### APPLICATION FOR CERTIFICATE OF APPROPRIATENESS

1800 Clinch Ave. 37916

# **Staff Report**

File Number: 1-D-23-HZ

# **PROPOSED ELEVATIONS**

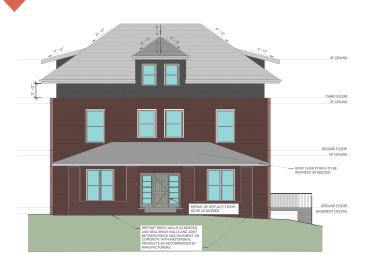
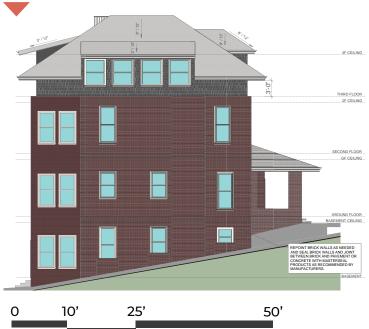
- 5. Guidelines recommend that second- and third-story construction use double-hung windows; the casement windows on the west elevation dormer should match the east elevation dormer's window size and design.
- 6. In general, the revision to side and rear elevation window placement maintains the recommended "proportions and symmetry," including additional transparency on the east elevation.
- 7. The remaining exterior rehabilitation scopes meet the design guidelines. All repointing and masonry repair should meet the specifications of NPS Brief 2, "Repointing Mortar Joints on Historic Masonry Buildings."

The Commission should determine the appropriateness of the upper-level roofline alterations/third-story addition. Pending HZC approval of the addition, additional conditions of approval should include: 1) windows on west elevation dormer to match east elevation dormer; 2) masonry repointing and brick repair to meet specifications of NPS Preservation Brief 2.
